Ilonka Aylward's Complaint

Exhibit 4

Notice of Intent to Commence Civil Action under Sections 301, 401, 402, 404 & 505 of the Clean Water Act and the North Carolina Sediment Pollution Control Act of 1973

The threatened and violations on 2813 Hinsdale Street, Charlotte, North Carolina, are incident to the City&Storm project known as "Hinsdale-Tinkerbell Stormwater Drainage Improvement Project" with the drainage area of approximately 240 acres and current estimated cost of construction \$7,900,000.

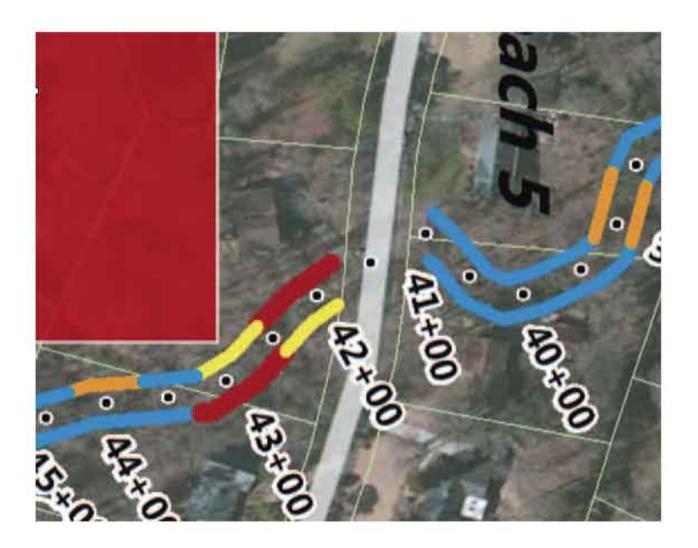
Over decades, storm water has been shooting at my bank from an illegally designed outfall, causing erosion.

DO NOT ANGLE STORMWATER PIPE AT 90 DEGREES TO THE RIGHT BANK! (EROSION)

On the left culvert wing wall, downstream part of Hinsdale Street culvert, there is a stormwater outfall designed faultily, and in violation of Clean Water Act: storm water hoses at right bank (where my house sits) at 90 degrees, and shoots water with such force that it undercuts the bank below.

U.S. Army Corps of Engineers warned Stormwater that existing outfall design, where stormwater shoots at 90 degrees across the creek, is faulty. Less than two hours after receiving directions from the U.S. Corps of Engineers, Charlotte-Mecklenburg Stormwater Services ("the CMSWS") secretly agreed between themselves to ignore the U.S.Corps's instruction.

- storm water outfall on left bank be redesigned, so that the run-off velocity and angle of the falling water no longer erodes the right bank
- right bank erosion that already happened be remediated
- culvert wings be redesigned to follow the bank, not cut into steep slope of the bank. culvert wing not be pushed back to the street, and not shortened
- on right slope, no grading above culvert and no grading downstream of the culvert
- no machinery or equipment stored (or traveling) on the right, steep bank of the creek
- no dynamite blasting

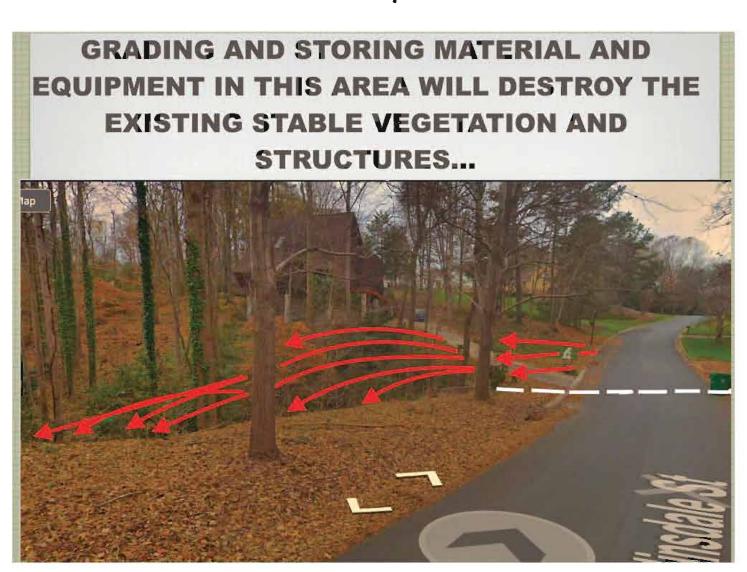
Stormwater flow will be increased by redirecting large additional flow from wider areas. CMSWS plans to **replicate** the 90 degree direction shooting at opposing bank in their new outfall. The only difference will be the increased flow.

Also, as shown with red arrows here, CMSWS plans to grade the steep slope above and downstream of the culvert, and far downstream, beyond construction area proper, in order to...

store heavy, vibrating machinery on steep slope over 20 feet tall.

CMSWS land-clearing plan includes:

removing trees, shrubs, vegetation cover with mechanized excavation activities,

extensive grading at prohibited angles 1.5:1), heights (over 10 ft) and without a buffer,

permanent change of bank contours,

destabilizing stream bank with heavy vibrating mechanized equipment and machinery,

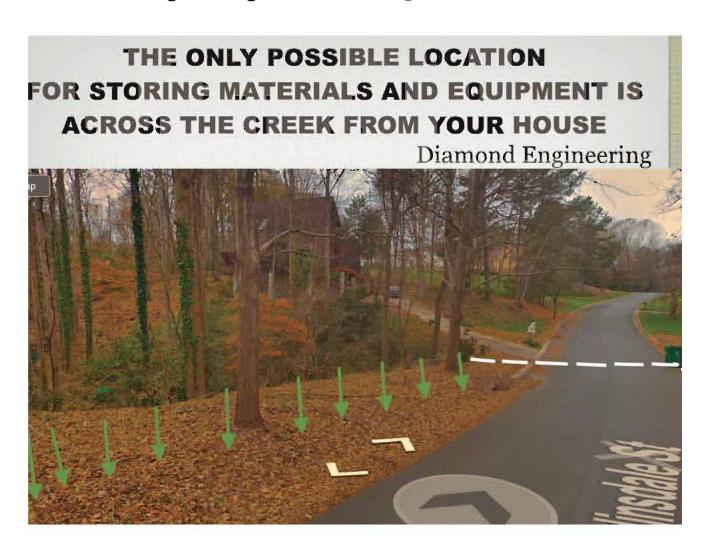
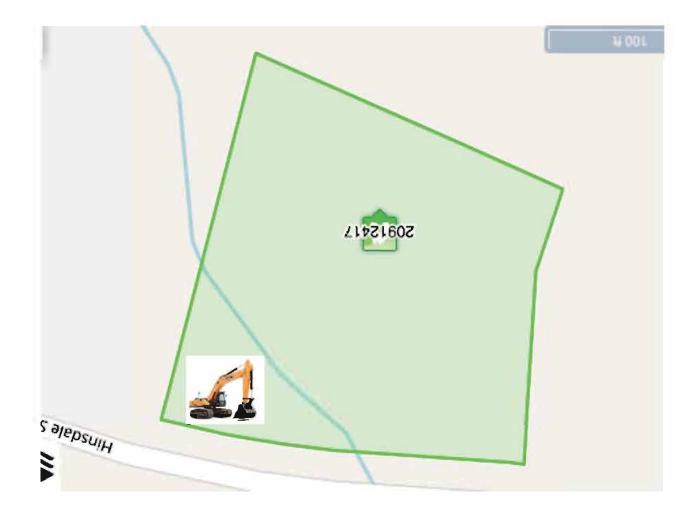
Importantly, there is no need to grade steep slope and cause erosion:

An easier access to construction site from left stream bank is on my land, and I am happy to grant access.

Diamond Engineering said so in its report.

I forwarded to CMSWS alternative designs which is safe, in compliance with Clean Water Act, and cheaper (See Diamond Engineering reports Attachments 2A and B)

Construction equipment icon marks part of the land where it is safer to keep equipment and materials and enter the construction zone.

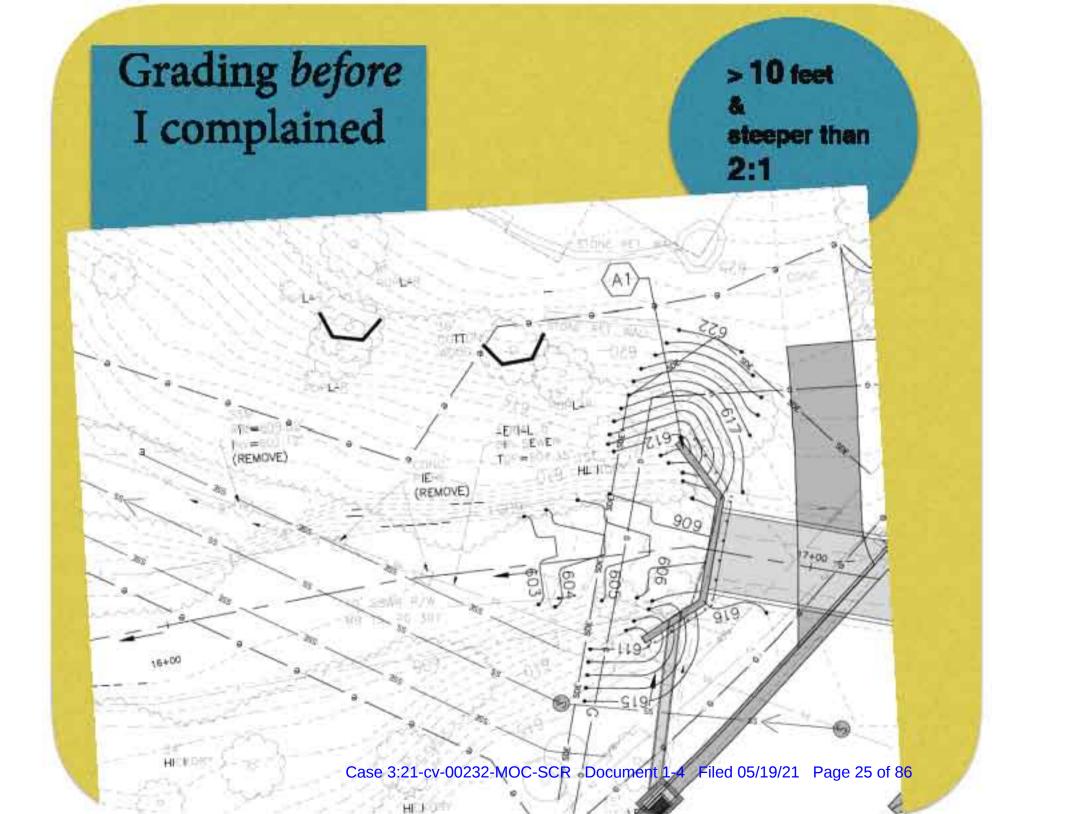
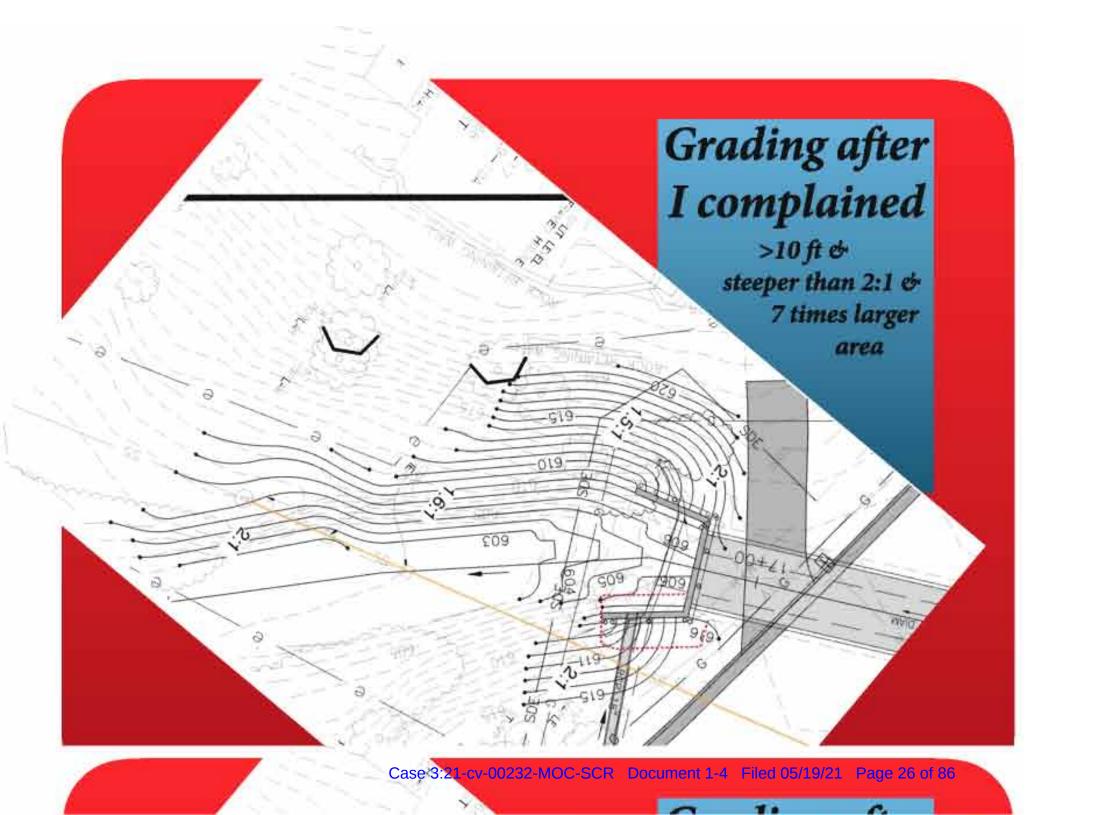
The insert here shows a close-up of grading threatened by CMSWS in early 2019, as compared to after I complaint to City Engineer in late 2019. The area to be graded is increased at least 7 times.

Note that *Department of the Army Regional General Permit* specifically commands: "Tree and shrub cover along the stream should be retained as much as possible in order to stabilize the stream banks."³

Exhibit Only - Not for Construction

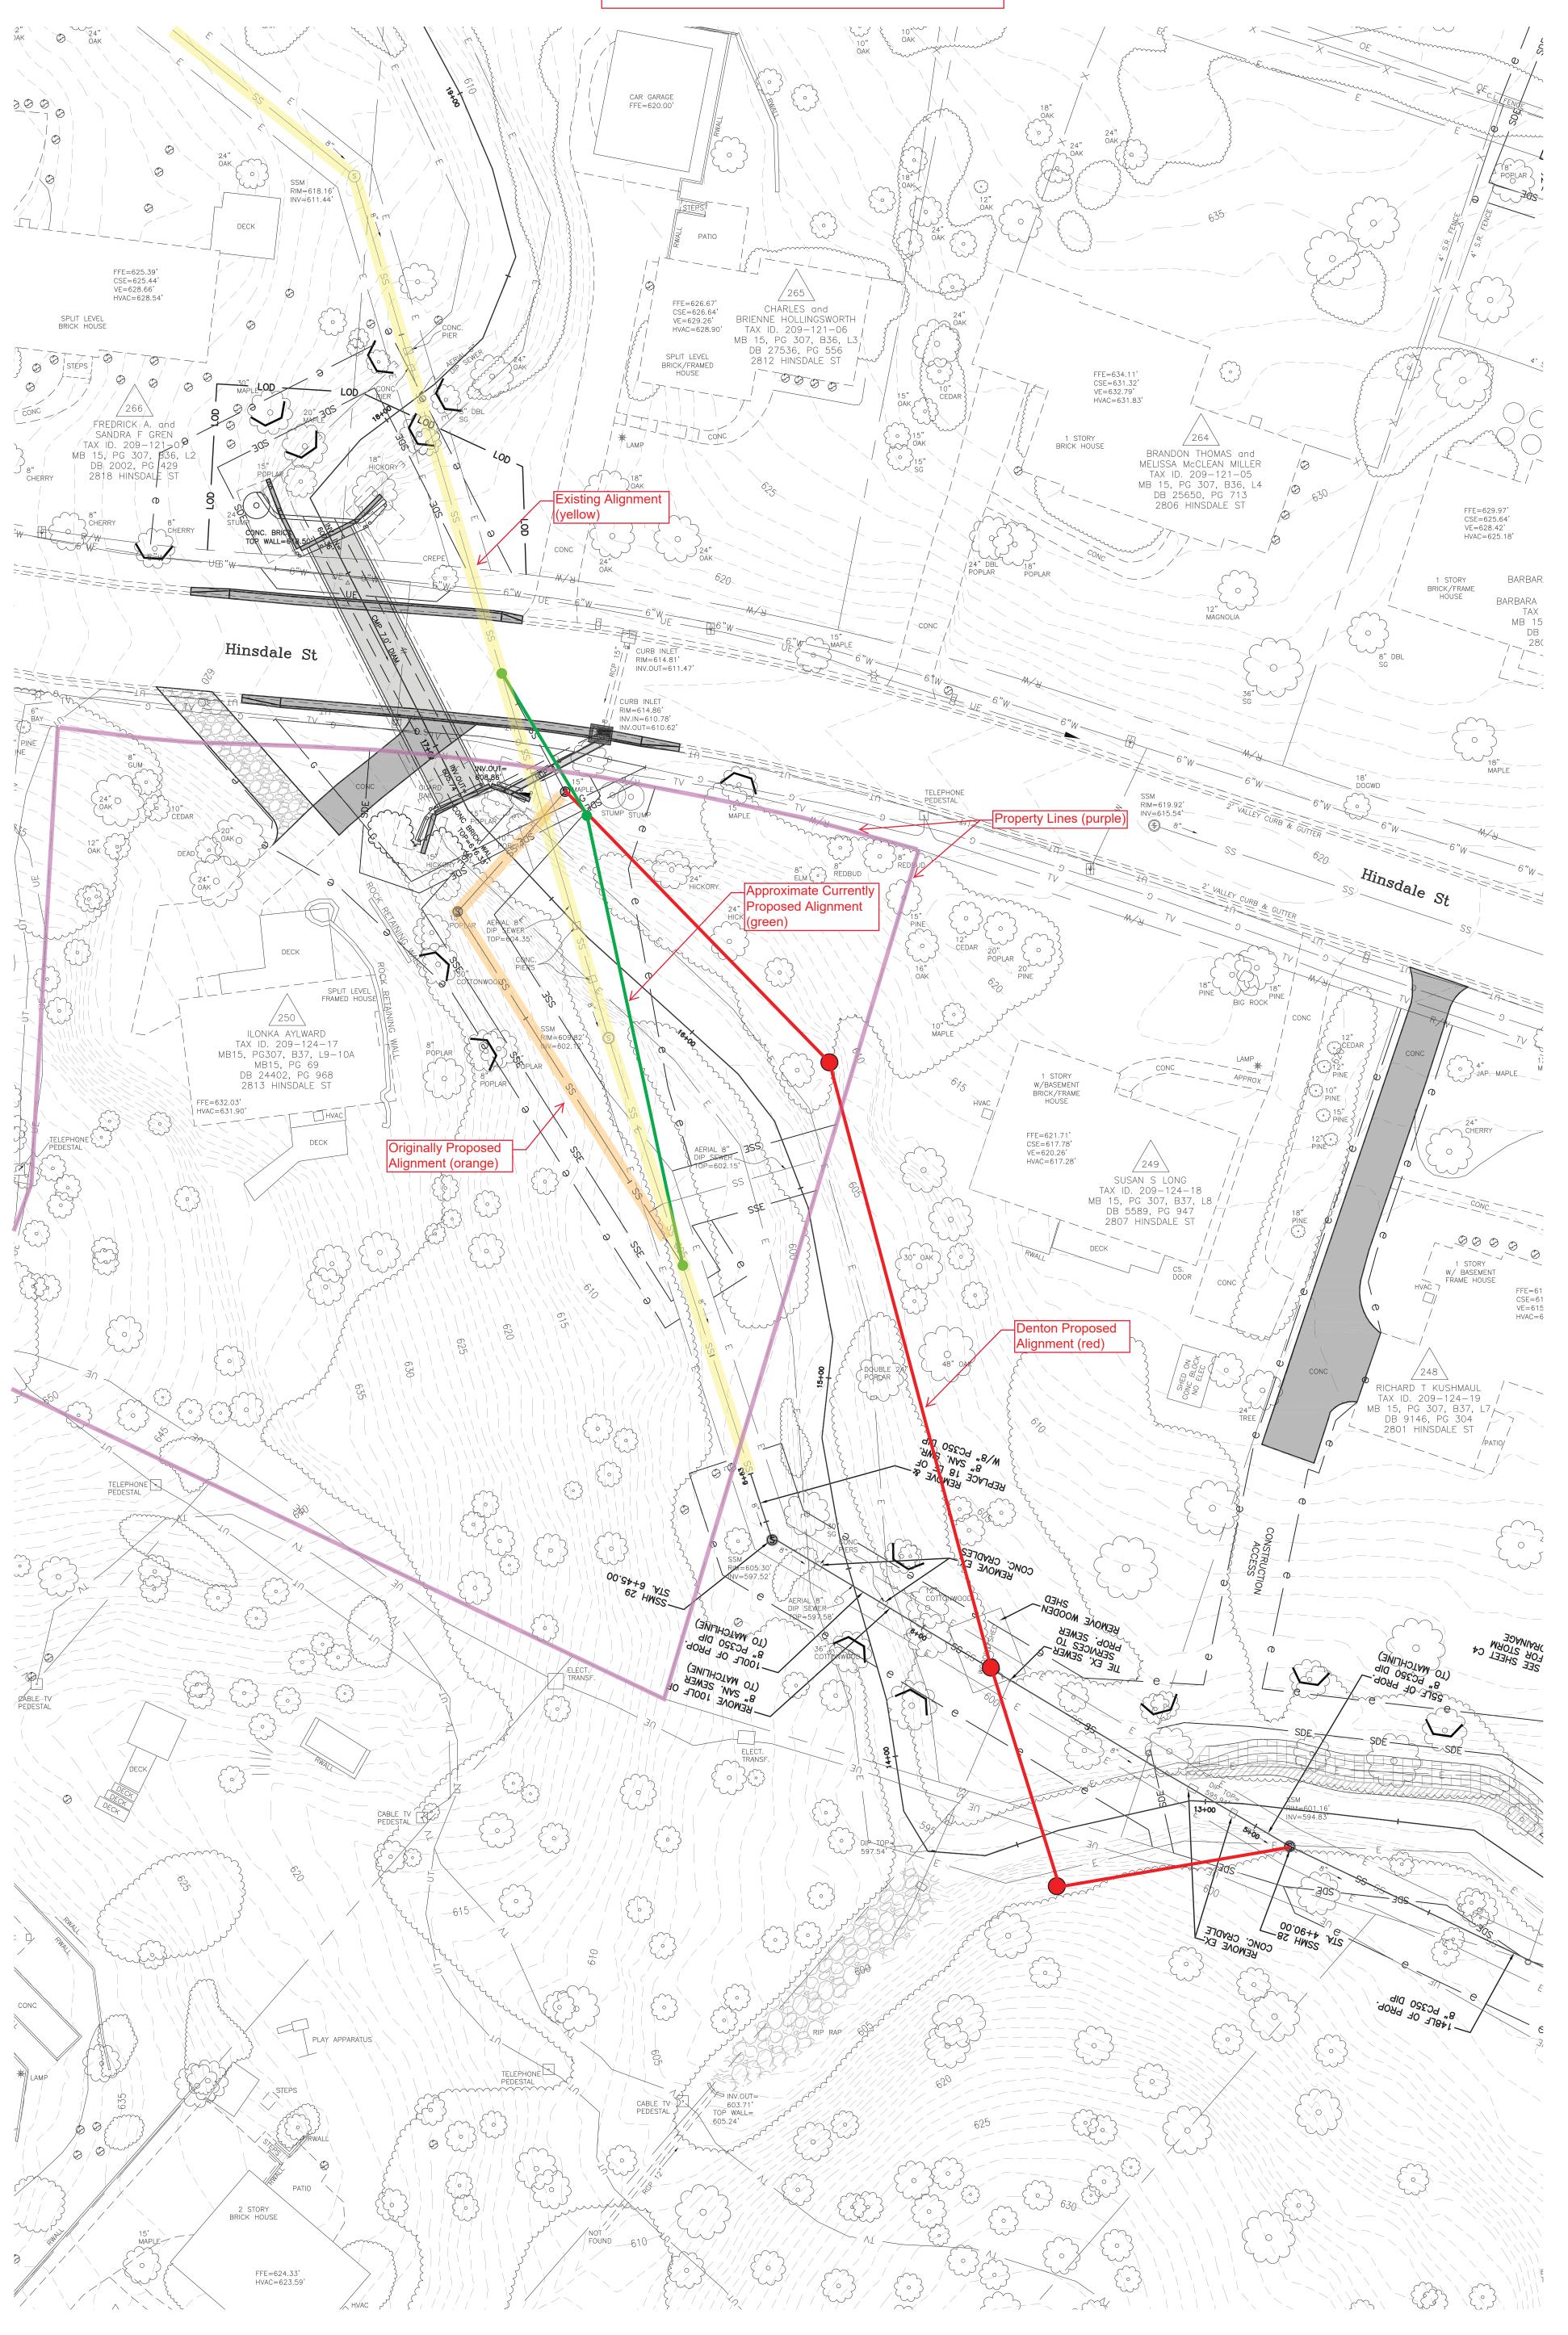
This correspondence is to document the findings of a review of the proposed plans to replace the storm drainage culvert on Hinsdale Street, adjacent to your property. I have reviewed, in particular, the slope at the southwest corner of the culvert. The slope closest to your residence, is proposed to be 1.5-1. The Slopes at all the other corners of the culvert is proposed to be 2:1. A typical and maintainable maximum slope for soils in the piedmont of North Carolina is 2:1. Slopes steeper than 2:1 are subject to slope failure and erosion due to the inability to obtaining and maintain an adequate vegetative cover. This proposed unstable slope is uncomfortable close to your residence and it is my recommendation that a redesign in this area is warranted. Grading in this area will destroy the existing stable vegetation and structures and will subject the house foundation to blasting and vibration from moving construction equipment.

My recommendation is that the end of the wing wall be rotated toward the creek and away from your residence. This would reduce the cut, reduce the slope, and eliminate the risk to your residence. Because the creek is bending to the left in this location, angling the wingwall away from your residence will also protect the creek bank in this area. This proposed change shouldn't cost any additional money to construct and can be constructed below the 616 contour which will limit the danger to your house and reduce the city's easement cost.

You also indicated that the city contractor is planning on storing materials and equipment on your property during construction. The only possible location for this would be across the creek from your house on the triangular lot of your property bounded by the creek, the road, and your eastern property line. Using this area wouldn't cause a significant disruption to your residence or disturb an area that might erode and cause structural damage to your house. Please review my comments and let me know if you have any additional questions.

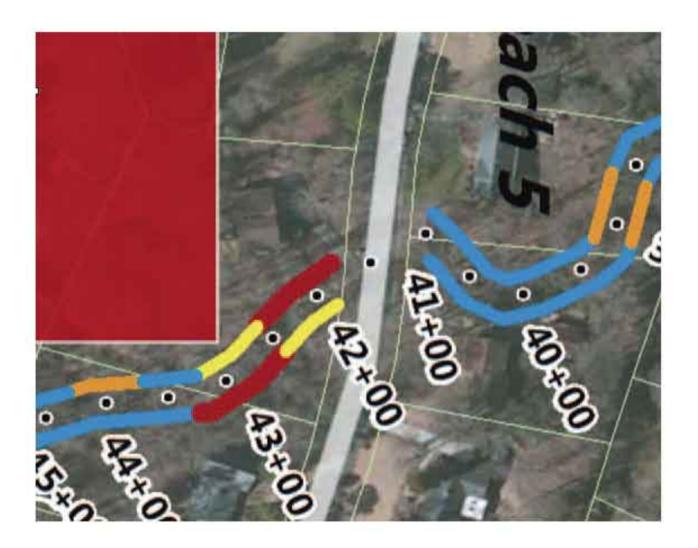
Over decades, storm water has been shooting at my bank from an illegally designed outfall, causing erosion.

DO NOT ANGLE STORMWATER PIPE AT 90 DEGREES TO THE RIGHT BANK! (EROSION)

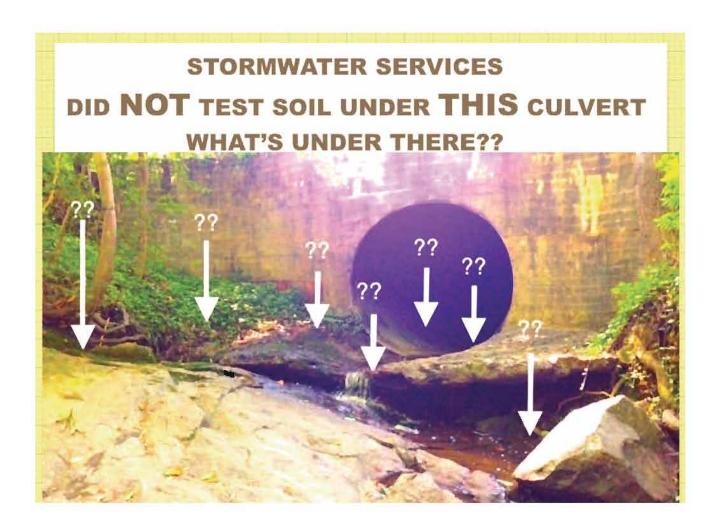
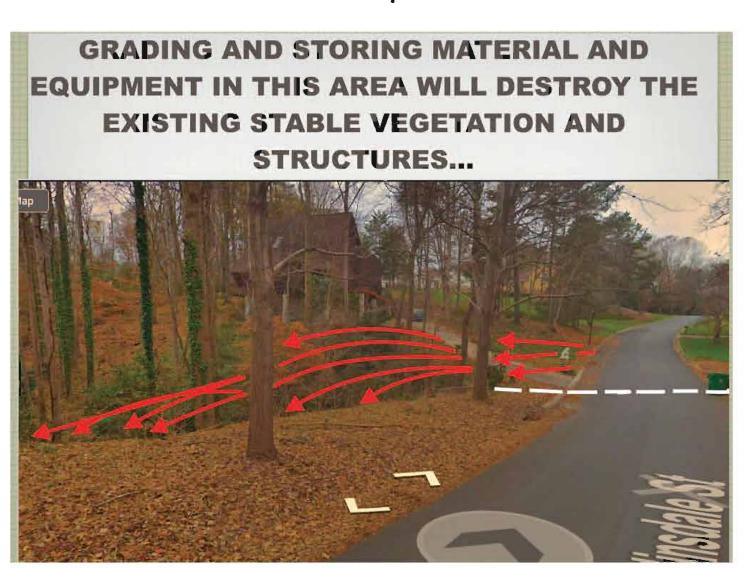
CMSWS land-clearing plan includes:

removing trees, shrubs, vegetation cover with mechanized excavation activities,

extensive grading at prohibited angles 1.5:1), heights (over 10 ft) and without a buffer,

permanent change of bank contours,

In contravention to Armstrong Glen Engineering and U.S. Army Corps of Engineers, CMSWS plans to construct Hinsdale culvert blind: without <u>any</u> prior soil analysis or Plan B in case there is no bedrock under the existing culvert pipe.

Additionally, U.S. Army Corps of Engineers warned CMSWS against blasting bedrock in the stream — but this warning also fell on deaf ears (more about this later in the Letter.)

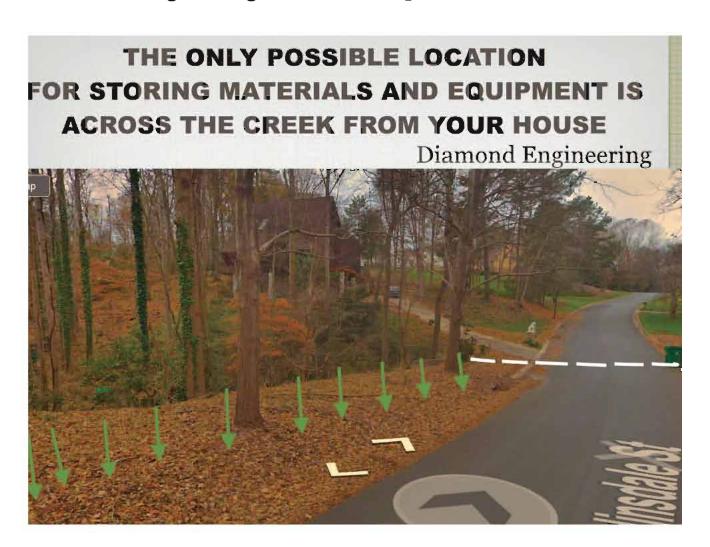
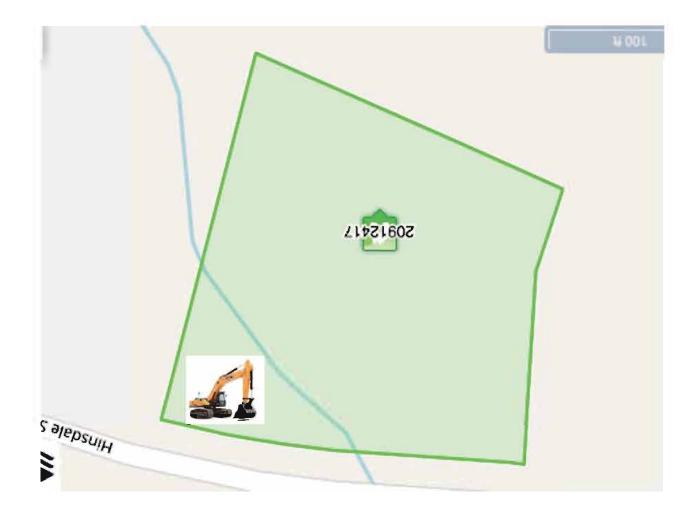
Importantly, there is no need to grade steep slope and cause erosion:

An easier access to construction site from left stream bank is on my land, and I am happy to grant access.

Diamond Engineering said so in its report.

I forwarded to CMSWS alternative designs which is safe, in compliance with Clean Water Act, and cheaper (See Diamond Engineering reports Attachments 2A and B)

Construction equipment icon marks part of the land where it is safer to keep equipment and materials and enter the construction zone.
